**SEQUOYAH FUELS CORPORATION**

December 28, 1987

Re: License No. SUB-1010; Docket No. 40-8027  
Improved Raffinate Treatment System

FIGURE 10.4-1

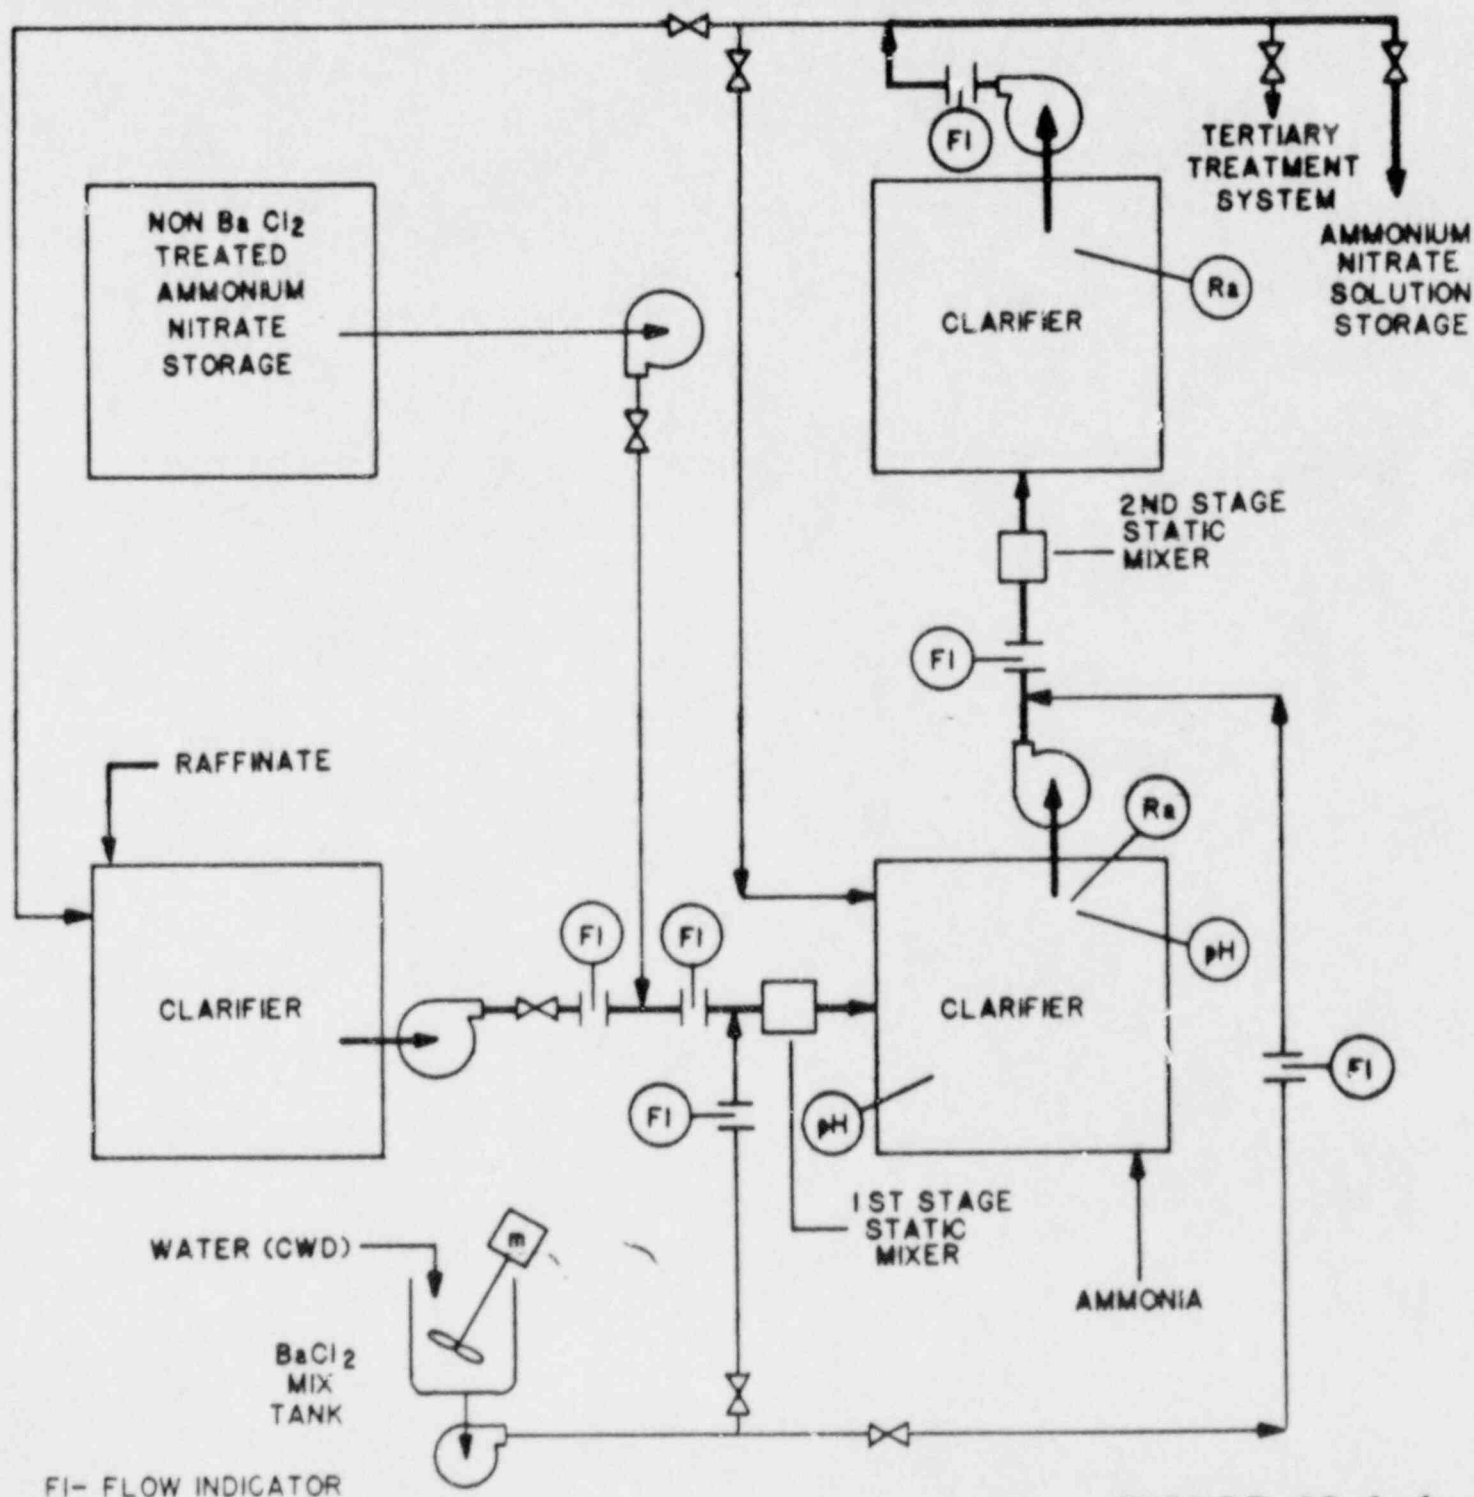
The attached revisions to Chapter 1, Section 1.8, page I.1-5 dated 12/07/87 and Chapter 10, Section 10.4.1 page II.10-12 dated 12/07/87 describe the improved treatment system. These revised pages replace pages I.1-5 dated 8/23/85 and page II.10-12 dated 8/20/86. Also included is a new figure 10.4-1, page II.10-12A.

The untreated stream (Figure 10.4-1) from S-X is pumped into a clarifier basin and allowed to cool. Barium chloride ( $\text{BaCl}_2$ ) is added to this low pH untreated raffinate through a static mixer as the raffinate is transferred to a second clarifier basin. where the pH is slowly adjusted with anhydrous ammonia from below 3.0 to approximately 7.5. Uranium, thorium, radium and trace metals are removed by this treatment process. The neutralized solution is then pumped through a second static mixer where additional  $\text{BaCl}_2$  is blended and discharged to a third basin to remove remaining radium. Ammonia is added as required during this solution transfer to maintain the 7.5 pH.

2. Neutralization of raffinate shall occur in two stages with barium treatment done in both stages. The pH shall be adjusted in stages slowly from below 3.5 to approximately 7.5 to increase the efficiency of the removal of Ra-226 and other trace metals.
